Access Compliance Report Public Rights-of-Way (Curb Ramps)

Intersection ID: 10034319 Main Street: PERIMETER PY **Cross Street: N/A** Location: SW Initial Pass/Fail: Fail **ADA ID: C98F12BDD577** Ramp Type: PerpDiag **Overall Compliance: No Severity Score:** 25

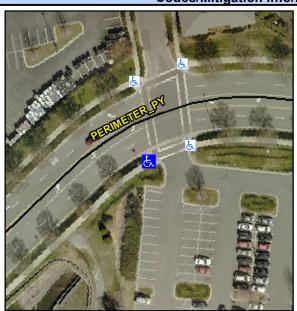
ENTRANCE StopSign **PERIMETER PY** None Possible Solutions: Remove & Replace Curb Ramp With **Two New Directional Ramps or** Equivalent. Surveyor Notes: N/A PROW/ADA: Not Found, R304.5.3

Field Measurements/Component Compliance					
Compliance Description		Data	Comp	liance Description	Data
N/A	Ramp Length (in)	72.0	Yes	Ramp Slope (%)	6.4
Yes	Ramp Width (in)	48.0	No	Ramp XSlope (%)	7.4
N/A	Flare Type LT	N/A	N/A	Flare Type RT	N/A
N/A	Flare Slope LT (%)	N/A	N/A	Flare Slope RT (%)	N/A
N/A	Flare Traversable LT?	N/A	N/A	Flare Traversable RT?	N/A
N/A	Landing Length (in)	N/A	N/A	DWS Provided?	N/A
N/A	Landing Width (in)	N/A	N/A	DWS Contrast?	N/A
N/A	Landing Slope (%)	N/A	N/A	DWS Length (in)	N/A
N/A	Landing X Slope (%)	N/A	N/A	DWS Full Width?	N/A
N/A	Landing Curb? (Y/N)	N/A	N/A	DWS Offset (in)	N/A
N/A	Shared Landing?	N/A			
N/A	Gutter Ponding?	N/A	N/A	Gutter Slope (%)	N/A
N/A	Gutter Lip Ht (in)	N/A	N/A	Gutter X Slope (%)	N/A
N/A	Painted X Walk1?	Yes	N/A	Painted X Walk2?	Yes
	X Walk 1 Direction	То Е		X Walk 2 Direction	To N
N/A	X Walk 1 Width (in)	71.0	N/A	X Walk 2 Width (in)	71.0
	X Walk 1 Slope (%)	2.2		X Walk 2 Slope (%)	4.8
